**Addendum to Technical Drainage
Study Update #2
For
Centennial Toyota
(aka: Prestige Chrysler / Dodge /
Ram / Jeep)**

JOB# 221203

December 2022

Subject: Addendum to Technical Drainage Study for Centennial Toyota
CLV No. DS2886C
(Lochsa Engineering Project No. 221203)

BMP Swale Capacity

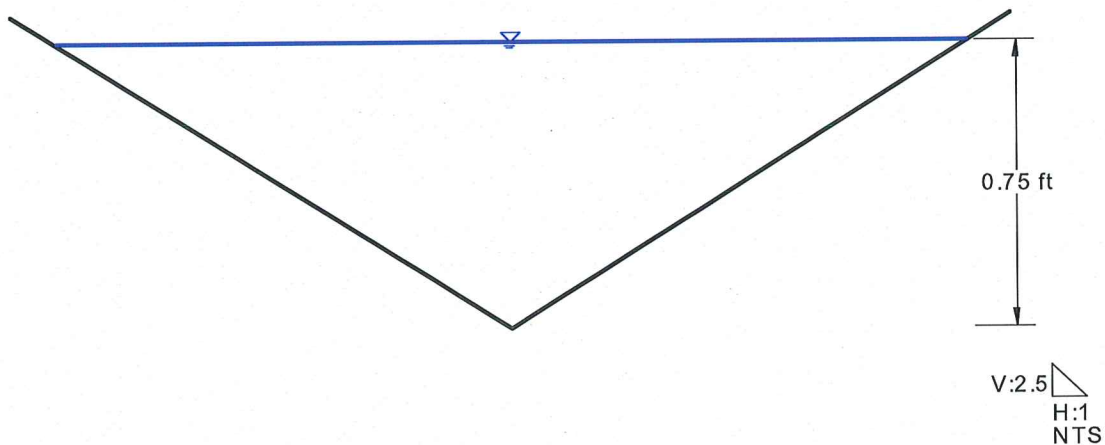
1. The overall parking lot improvement area is larger than 1 acre. Per **Section 1500** of the Clark County Regional Flood Control District's Hydrologic Criteria and Drainage Design Manual, the subject improvements must provide for Low Impact Development (LID) measures. Review and address the issue in the next submittal.

COMMENT #1

Response 1: Noted. We have provided an 80ft long BMP swale and 40ft BMP swale at the SEC of the improvements to treat a minimum of 75% of the parking lot improvements. We have provided 4" riprap in the BMP swales. See provided calculations.

BMP swale treats 1.80 ac

$$1.80 \text{ ac} \times \frac{.5 \text{ cfs}}{\text{Acre}} = \underline{\underline{.90 \text{ cfs}}} < 5.16 \text{ cfs capacity}$$
